ENGINEER CHANGE ORDER (ECO) ANALYSIS FORM

Manufacturer:	Unisyn	
System:	OVS 2.0.A (Freedom Vote Tablet)	
ECO Number:	16979	
ECO Description:	Change positions of keys on ADA Keypad

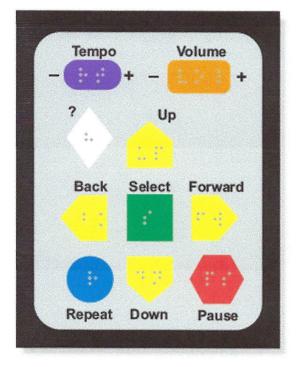
A source code review was performed comparing the changes to the baseline source code for OVS 2.0A. This review showed modifications to two files: Constants.java and Acitivity_test_keypad.xml. These changes consisted of switching assignment of two constants, KEY_RIGHT and KEY_ENTER, in the Constants.java file. Below is the comparison for this change:

Old Keypad Layout

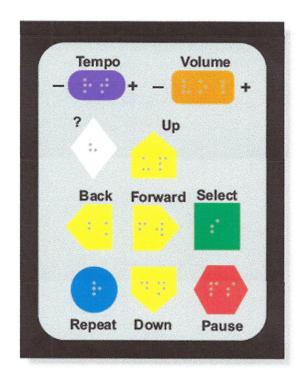
ECO# 16979 also includes the repositioning for the yellow 'Forward' button and the green 'Select' button. Below is a side-by-side comparison of the diagrams depicting the old and new keypads.

- The hardware change consists of the repositioning of the physical button. These buttons have no electronic components associated with them. Although in different positions at the time, the buttons were present for all testing in the original test campaign.
- It is Pro V&V's determination that the software modifications implemented to switch the assignment of the functionality of the buttons pressed for the 'Forward' key and the 'Select' key do not alter the functionality for these components (the buttons are still being pressed to make a selection or to navigate the ballot). The original system tested utilized the same code; the functionality has just been reassigned to different positions.
